TENNESSEE VALLEY AUTHORITY

In the Matter of
Tennessee Valley Authority

) Docket No. 50-328
)

RESPONSES TO NRC QUESTIONS

FIGURE 1-1

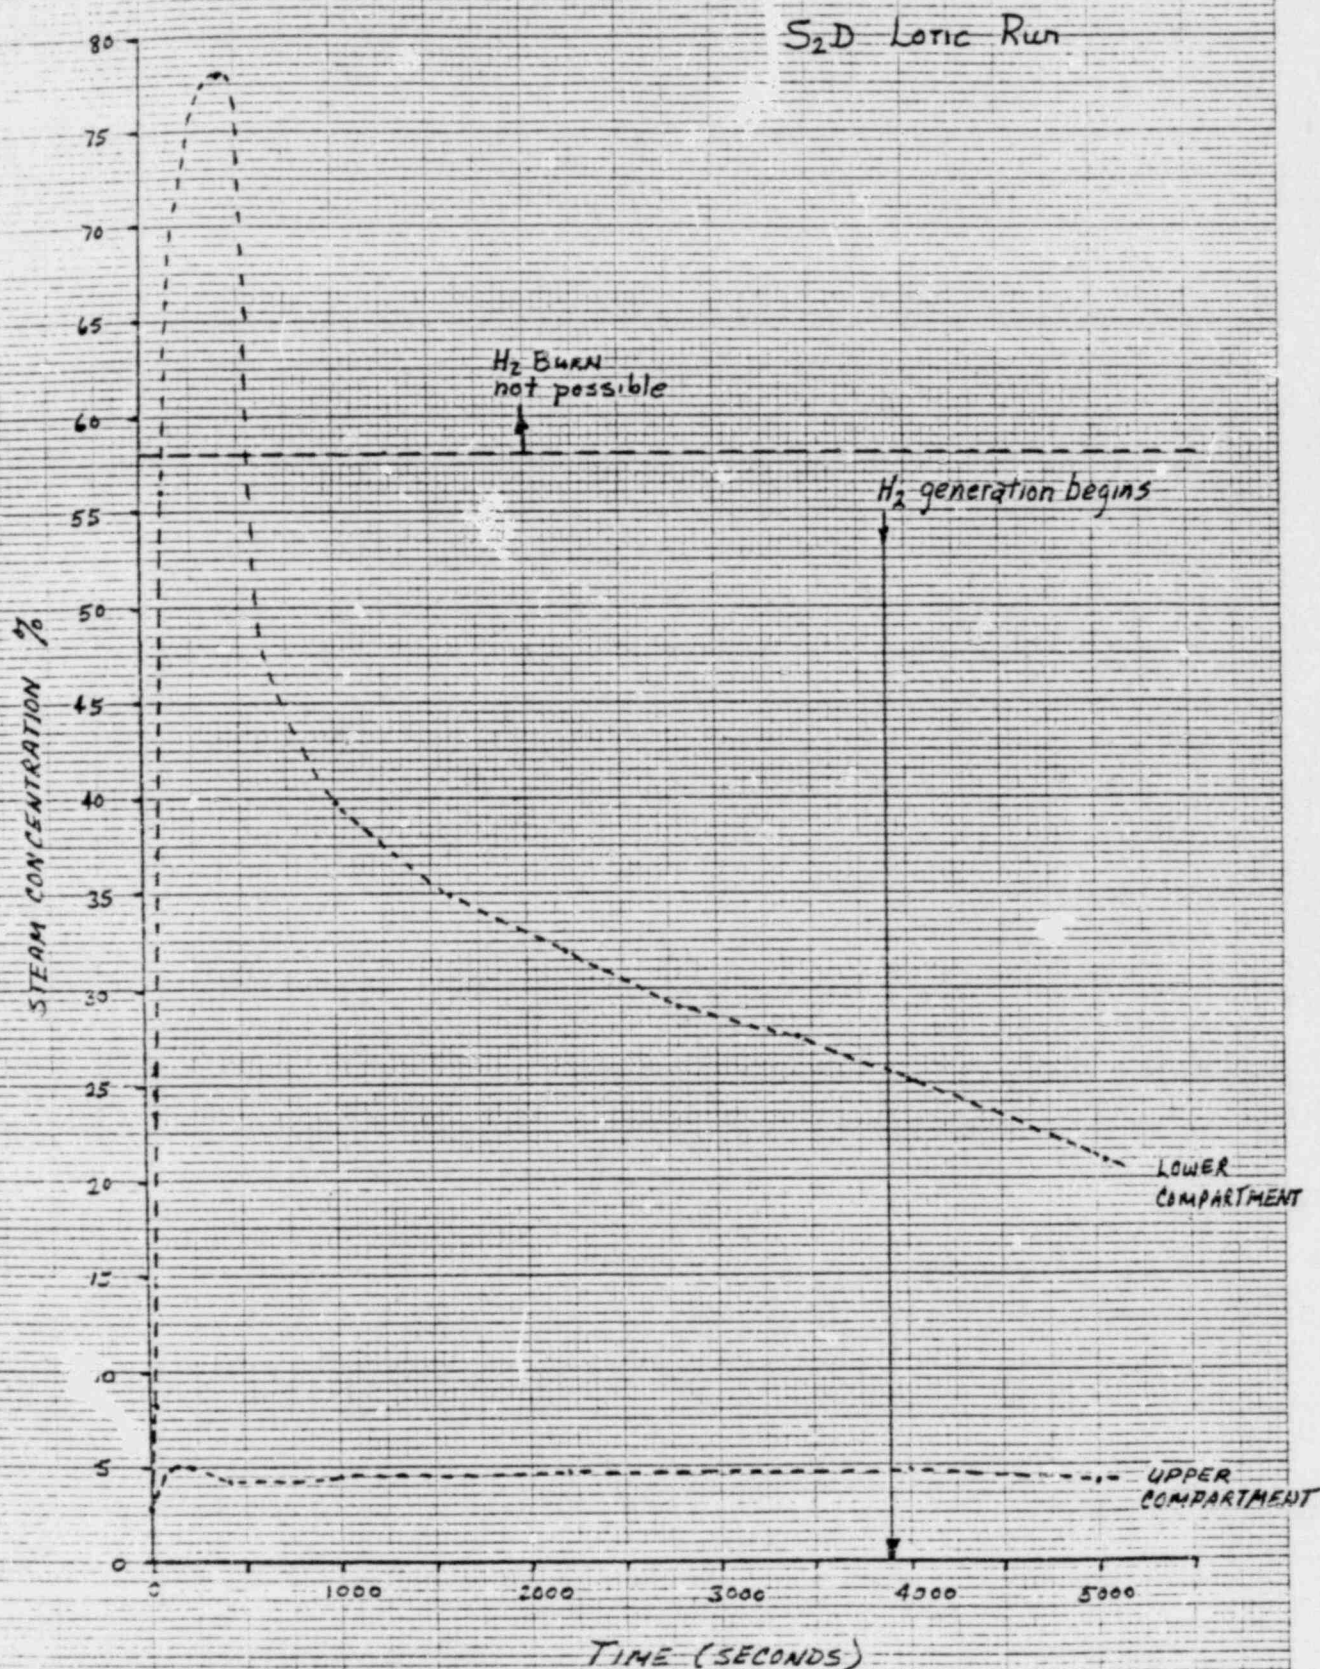
TVA views on the likelihood for inerting of the lower compartment with steam and/or fog

TVA does not believe that the lower compartment would be inerted with either steam or fog following a small break (S₂D-type event during the time in which significant amounts of hydrogen could be released into containment. By definition, an inerted atmosphere would not be flammable for any concentration of hydrogen. For example, a 60-percent concentration of steam by volume would effectively inert any hydrogen-rich atmosphere. However, a smaller steam fraction could prevent the combustion of a very low hydrogen concentration mixture that might otherwise be flammable without steam simply by depressing the concentration below the lower flammability limit. (A mixture with a steam fraction of less than 60 percent by volume would not be inerted for concentrations of hydrogen above the lower flammability limit.)

As explained in our response of December 1, 1980, to the NRC Request for Additional Information on the Sequoyah Interim Distributed Ignition System (IDIS), Volume 2, item 4, the concentration of steam during the long term following a small break when hydrogen could be present is sufficiently low to have little effect on flammability limits and, therefore, the behavior of the igniters. When the air return fans are turned on at ten minutes after a phase B containment isolation signal, the lower compartment atmosphere is diluted with 80,000 cfm of air and rapidly deinerted. This occurs long before hydrogen generation would be expected. (See attached figure 1-1 from our previous submittal.)
